HARDING HYDRO

Our ref: 10003-L001Rev01

Former Marchon Site, Pow Beck Valley and area from Marchon Site to St Bees Coast, Whitehaven, Cumbria - Application for development of a new underground metallurgical coal mine to include a buried conveyor at Roska Park and Bellhouse Gill Woods and associated development ("the Proposal"): Illustration of potential impacts and mitigation

Scenario 2: Tunnel below water table (fully blocking)

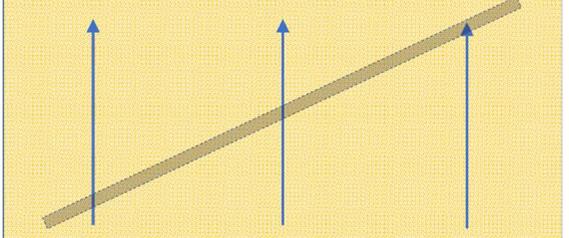
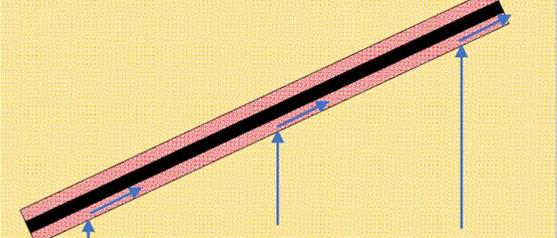
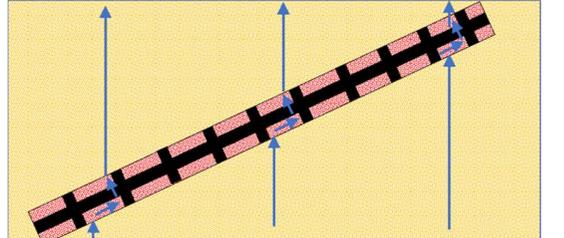
<p>Pre-construction conditions as per Scenario 1 except that proposed tunnel would be partly or fully below the water table and occupy the full thickness of the unsaturated zone.</p> <p>This could be the case at Zone 1 and Zone 2.</p>	<p>Tunnel acts as impermeable block within aquifer and impedes groundwater flow. Groundwater will back up upgradient of the tunnel until it reaches a sufficient height to flow over the obstruction. If groundwater reaches the surface, waterlogging and groundwater breakout may occur. Dropping of downgradient groundwater levels less likely as total flow across the obstruction will ultimately remain unchanged unless there is a large amount of surface discharge.</p>	<p>Provide permeable pathway below tunnel. Water can continue to flow beneath the tunnel unimpeded and hence will not back up. Pathway could take the form of a jacket around the structure or a number of drains going beneath it, connecting the aquifer on the upgradient and downgradient sides.</p>
